STAFF CASE REPORT TO PLANNING COMMISSION

Subdivision Case Number:	2015-071	PC Meeting Date: 12-14-15
Subdivision Name:	Sleepy Hollow Subdivision Resub of Lots 21, 22, and 23 Urban Infill Lot Compatibility Option	
Applicant Request:	Urban Infill Lot Compatibility Option	
Property Location:	917 Dartmouth Avenue	
Property Owner:	KC Enterprises, CO Jason Sides	
Applicant:	Jason Sides and Jack Reid Surveying	
Total Acreage:	0.28 Acres	
Proposed Density:	7.14 dwelling units per acre	
Tax Map Number:	127I-A-023	
Zoning:	R-1 Residential Zone	
Staff Recommendation:	APPROVE, Urban Infill Lot Compatibility Option

BEING: RESUB. PART OF LOTS 21, 22 and 23, SLEEPY HOLLOW SUBD. INTO 2 LOTS

PLOT PLAN

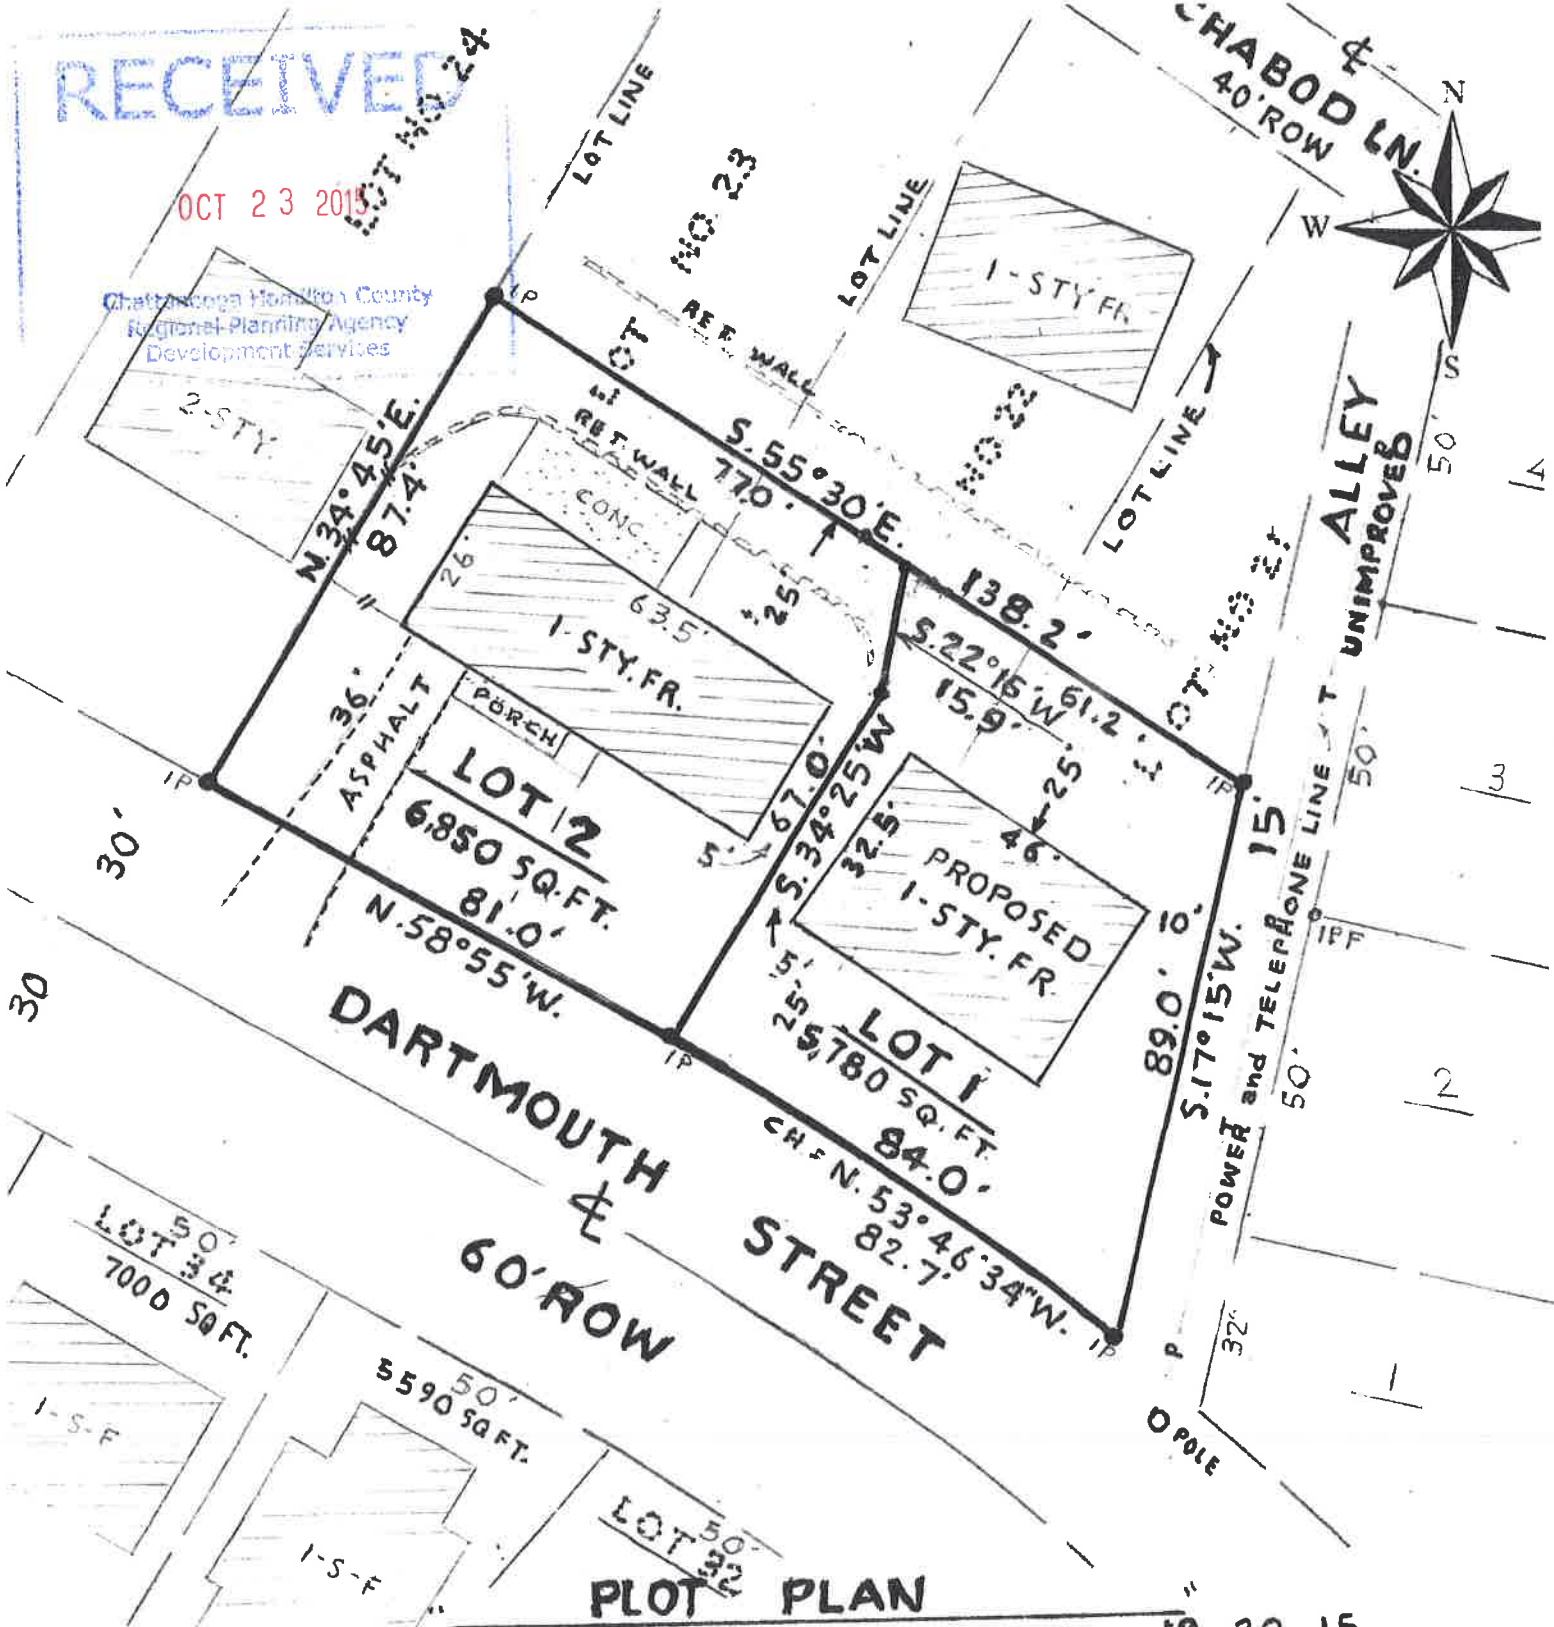
The average frontage of the surrounding lots is multiplied by 90% to obtain the minimum lot frontage required for compatibility. The average lot frontage along Dartmouth Avenue is 50'; therefore, the minimum lot frontage required for the Urban Infill Lot Compatibility Option is 45' (50' X 90%). Proposed lots 1 and 2 comply with and exceed the minimum lot frontage requirements of the Urban Infill Lot Compatibility Option. The proposed lot frontage are as follows: Lot 1: 84' Lot 2: 81'.

The average lot area of the surrounding lots is multiplied by 75% to obtain the minimum lot area required for compatibility. The average lot area along Dartmouth Avenue is 7,702 square feet; therefore, the minimum lot area for the Urban Infill Lot Compatibility Option is 5,777 square feet (7,702 X 75%). Proposed lots 1 and 2 comply with and exceed the minimum lot area requirement of the Urban Infill Lot Compatibility Option. The proposed lot sizes are as follows: Lot 1: 5,780 Lot 2: 6,850.

If the infill lot is an interior lot there shall be a side yard of not less than five (5) feet. The 5' side yard setback is the minimum required and meets the requirements of section 38-480 of the Chattanooga Zoning Ordinance. The proposed side yard setback for the existing and proposed structures on Lots 1 and 2 appears to be a minimum of 5' in compliance with the provisions of the Chattanooga Zoning Regulations.

There shall be a rear yard setback of 25'. The 25' rear yard setback is the minimum required and is in compliance with section 38-480 of the Chattanooga Zoning Ordinance. The proposed rear yard setback for the existing and proposed structures on Lots 1 and 2 appears to be a minimum of 25' in compliance with the provisions of the Chattanooga Zoning Regulations.

Approve the Urban Infill Lot Compatibility Option
